<b>Docket Number:</b>	09-AFC-07C
<b>Project Title:</b>	Palen Solar Power Project - Compliance
<b>TN #:</b>	200268
<b>Document Title:</b>	Email re CEC request for GIS data 08132013
<b>Description:</b>	CEC request for GIS data in re Mojave fringe toed lizard
<b>Filer:</b>	Ann Crisp
<b>Organization:</b>	Neil Storey
<b>Submitter Role:</b>	Applicant's Consultant
<b>Submission Date:</b>	8/20/2013 10:55:40 AM
<b>Docketed Date:</b>	8/20/2013

**From:** Neil Storey [neil@spatialds.com]  
**Sent:** Tuesday, August 13, 2013 9:03 AM  
**To:** Gilbreath, Jacque@Energy  
**Cc:** Crisp, Ann@Energy; 'Andrea Grenier'; 'Charlie Turlinski'  
**Subject:** RE: CEC request for GIS data and help understanding a discrepancy of acreage numbers  
**Attachments:** PSEGS Construction Phases MFTL.zip

**Here are the figures which we created for Ann Crisp from the latest GIS data we have from you.**

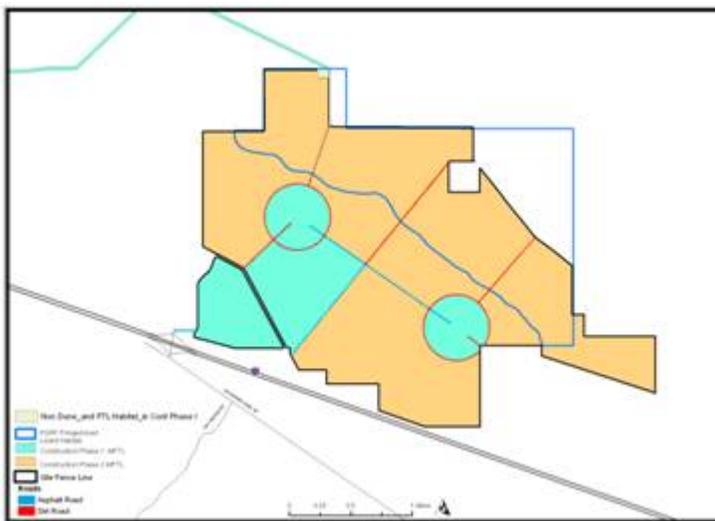
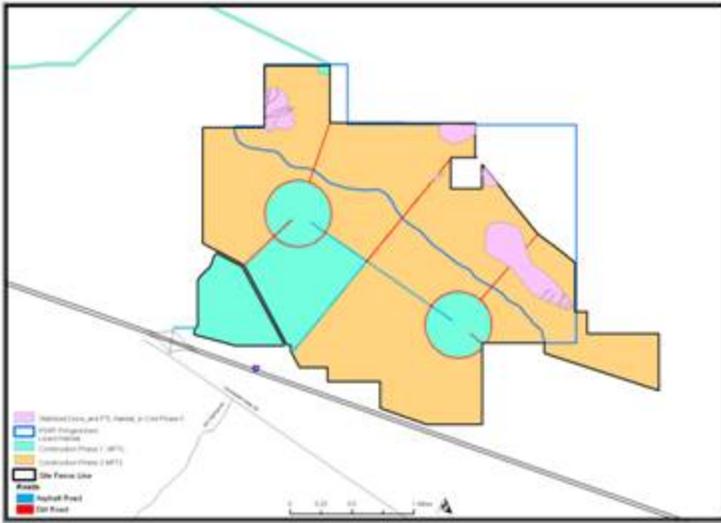
- 1) PSPP\_FTL\_Habitat within Stabilized and Partially Stabilized Desert Dunes and within Construction Phase I = 0 Acres

2) PSPP\_FTL\_Habitat within Stabilized and Partially Stabilized Desert Dunes and within Construction Phase II = 184.4433 Acres

3) PSPP\_FTL\_Habitat within Non Dunes and within Construction Phase I = 6.5380 Acres

4) PSPP\_FTL\_Habitat within Non Dunes and within Construction Phase II = 1,071.3014 Acres

Ann Crisp is saying that the acreage count is different between the GIS data we currently (and we made the maps from) and the data that the Palen project owners submitted to the CEC in Phase 1. Can you address why the data is different or send the GIS data that the Palen project owners submitted to the CEC?

One discrepancy I noted from the email is that the reported acreage also includes the Gen-Tie linear corridor. With this, the Phase I Non-Dune impacts are 34.2 acres. Phase II Non-Dune impacts are 1258.2 acres, and the Phase II Stabilized and Partially Stabilized Desert Dunes is 186.8 acres.

Also, your email below references PSPP (the original approved project) rather than PSEGS. It is difficult to read the legend on the attached screen captures, but I assume this is a typo.
